## Proposal for to the 05 series of amendments of Regulation No. 95 – protection of the occupants in the event of a lateral collision

### Submitted by the experts from Japan on behalf of Task Force

The text reproduced below has been prepared by the expert from Japan on behalf of Task Force to amend the requirements concerning post-crash electrical safety in the event of lateral collision. The modifications to the current text of the Regulation are marked in bold for new or strikethrough for deleted characters.

**Figure 3**  
**Jointed Test Finger**

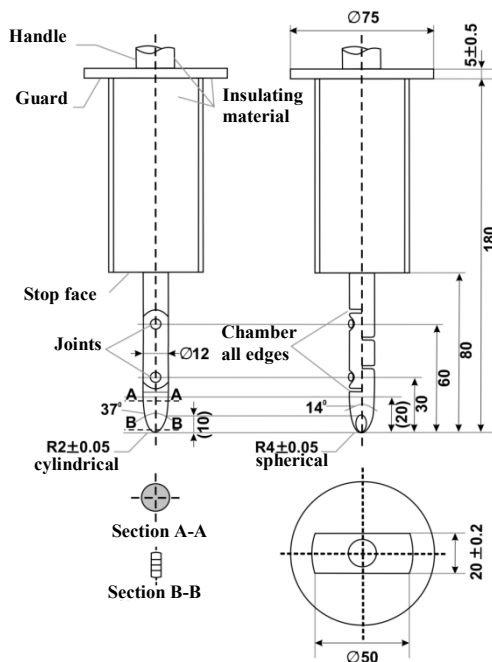
The jointed test finger described in ~~Figure 31 of Appendix 1~~ **Figure 3** shall be inserted into any gaps or openings of the physical protection with a test force of 10 N ± 10 per cent for electrical safety assessment. If partial or full penetration into the physical protection by the jointed test finger occurs, the jointed test finger shall be placed in every position as specified below.

The requirements of paragraph 5.3.7.1.3. of this Regulation ~~are shall be considered to be~~ met if the jointed test finger described in Figure 31 ~~of Appendix 1~~, is unable to contact high voltage live parts.

Figure 4

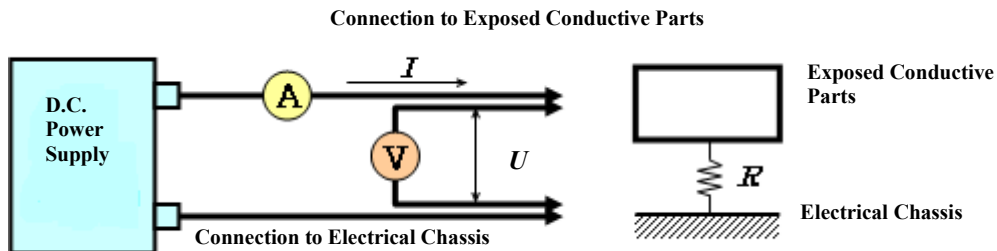
The DC power supply, voltmeter and ammeter are connected to the measuring points (Typically, electrical chassis and electro conductive enclosure/electrical protection barrier).

The voltage of the DC power supply is adjusted so that the current flow becomes at least 0.2 A.

The current "I" and the voltage "U" are measured.

The resistance "R" is calculated according to the following formula:

$$R = U / I$$

The resistance R shall be less than 0.1 Ω.

*Note:* If lead wires are used for voltage and current measurement, each lead wire shall be independently connected to the electrical protection barrier/enclosure/electrical chassis. Terminal can be common for voltage measurement and current measurement.

Example of the test method using DC power supply, voltmeter and ammeter is shown below.

Figure 5  
Measurement of  $U_1'$

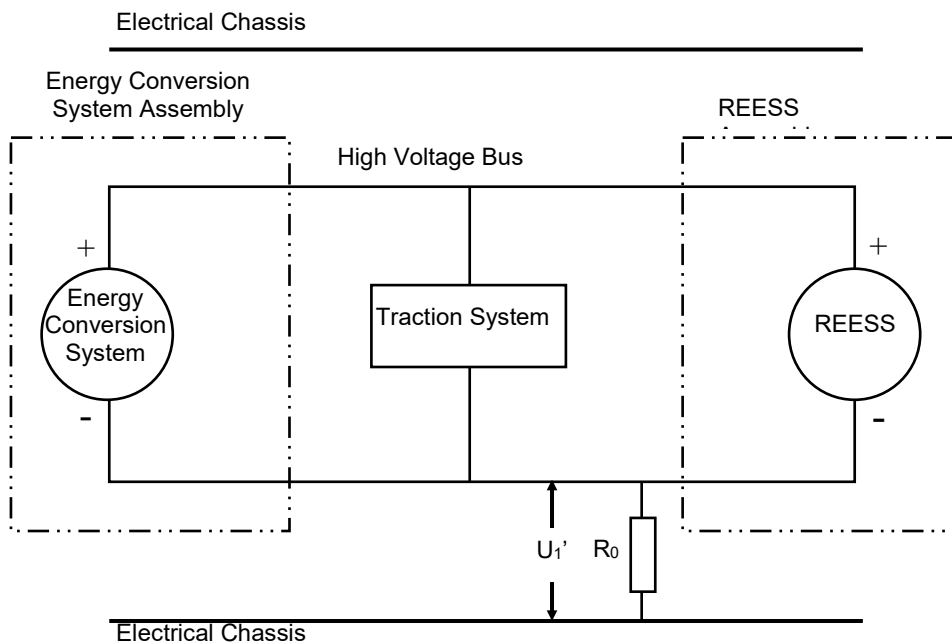
If  $U_1$  is greater than or equal to  $U_2$ , a standard known resistance ( $R_o$ ) is inserted between the negative side of the high voltage bus and the electrical chassis. With  $R_o$  installed, the voltage ( $U_1'$ ) between the negative side of the high voltage bus and the electrical chassis is measured (see Figure 5).

The electrical isolation ( $R_i$ ) is calculated according to the following formula:

$$R_i = R_o * U_b * (1/U_1' - 1/U_1)$$

Figure 6  
Measurement of  $U_2'$

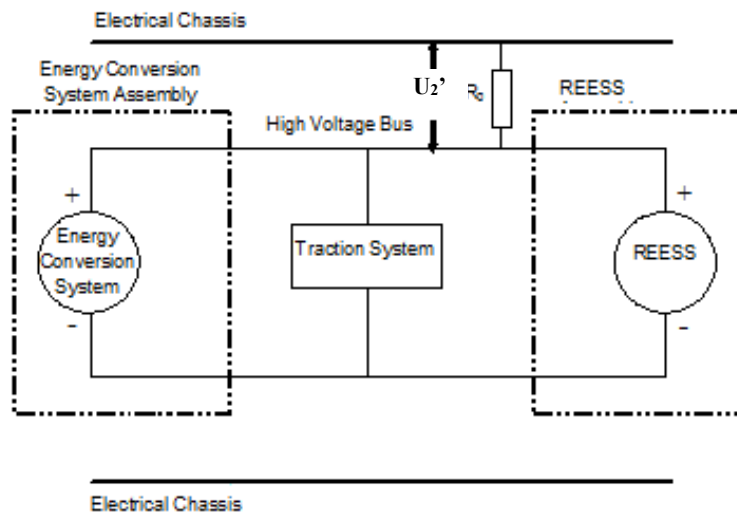
If  $U_2$  is greater than  $U_1$ , insert a standard known resistance ( $R_o$ ) between the positive side of the high voltage bus and the electrical chassis. With  $R_o$

installed, measure the voltage ( $U_2'$ ) between the positive side of the high voltage bus and the electrical chassis (see Figure 6 below). The electrical isolation ( $R_i$ ) is calculated according to the following formula:

$$R_i = R_o * U_b * (1/U_2' - 1/U_2)$$
